SEPTIC IMPROVEMENT PERMIT / AUTHORIZATION TO CONSTRUCT / OPERATION PERMIT / EXISTING SYSTEM

SITE ADDRESS: ✓135 Hobbs Lane Mooresville, NC 28115 PHONE: 704-658-8616 ALT. PHONE

SUBDIVISION: ✓Torrence Tavern Estates SECTION: B LOT # 2 LOT AREA: 1.69 acres DESIGN FLOW: 360 GPD L.T.A.R.: 0.25

From: Kayla Wilson
Sent: Tuesday, December 4, 2018 4:00 PM
To: bossmb86@yahoo.com
Subject: 135 Hobbs Ln

AS BUILT SKETCH

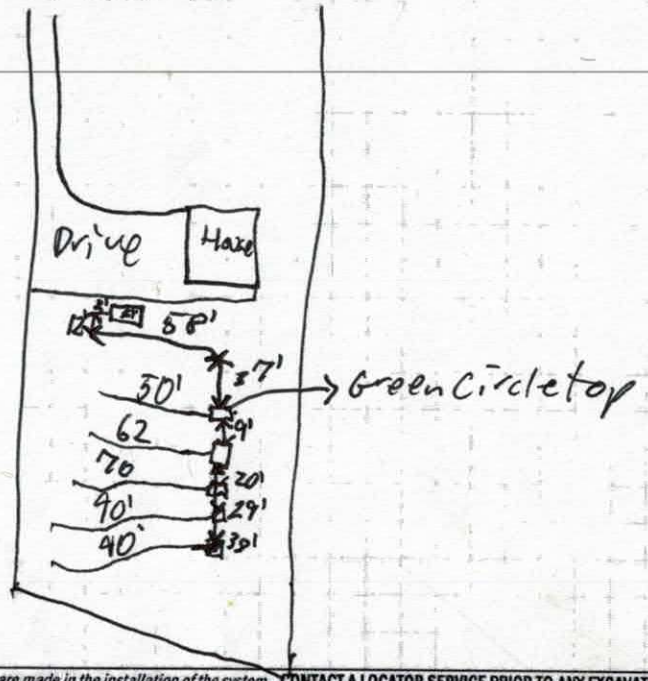
11/30/18: Checked part of system. All drain lines will need to be installed deeper.

The following need to be addressed per the inspection on 12/4/18:
-The last drain line cannot be covered until drain line is completely dry
-The last drain line is not level due to the first 3-4 chambers (on right facing toward back of property) having over 2" of fall
-The last drain line needs to be installed at least 6" deeper due to chambers being at grade (12")
-The entire length of the middle drain line needs to be installed deeper to maintain level and to achieve 18" on low side
